**15-730, 15-734, 15-736 & 15-738**

**Ford 5.0 Coyote Oil Pans.**

### **15-738 Front Sump Pan.**

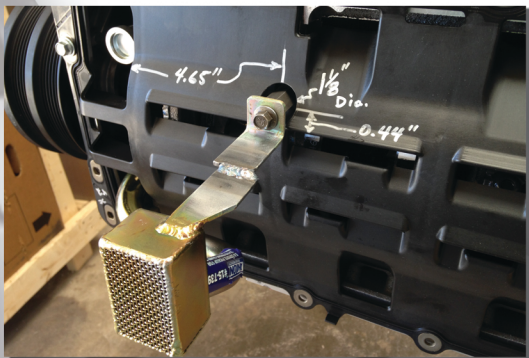
Due to the lack of OEM front sump Coyote applications there are a few modifications needed to properly install our front sump coyote pan.

Image left shows the location you will need to modify the tray in order to properly mount the pickup tube. In addition to this modification you will also need to move the pickup mounting bolt from the OE position to this location.
